REMARKS

In view of the above amendments and following remarks, reconsideration of the objections and rejections that are contained in the Office Action of April 25, 2011 is respectfully requested.

[Reference Figure 1]

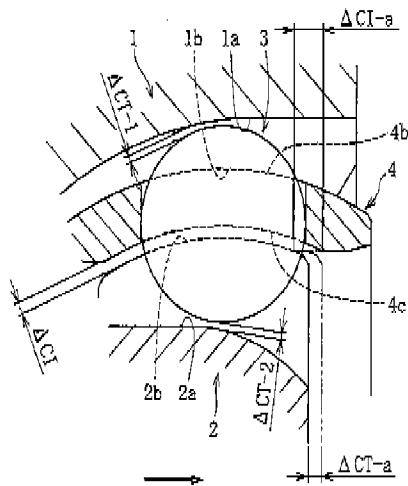
Usually in this type of the constant velocity universal joint, as shown in reference figure 1 below, there are clearances $\Delta CT-1$ and $\Delta CT-2$ between the track groove 1a of the outer member 1 and the ball 3, and between the track groove 2a of the inner member 2. The sum of the clearances $\Delta CT-1$ and $\Delta CT-2$ is the track clearance between the ball track and the ball.

[Reference Figure 2]

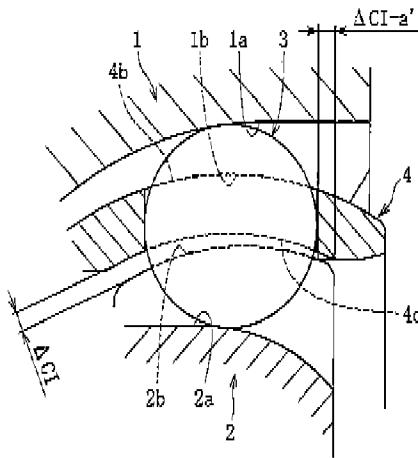
The reference figure 2 below shows the state in which the track clearance ($\Delta CT-1$ and $\Delta CT-2$) is cleared up by the elastic force to make the ball contact with the ball track.
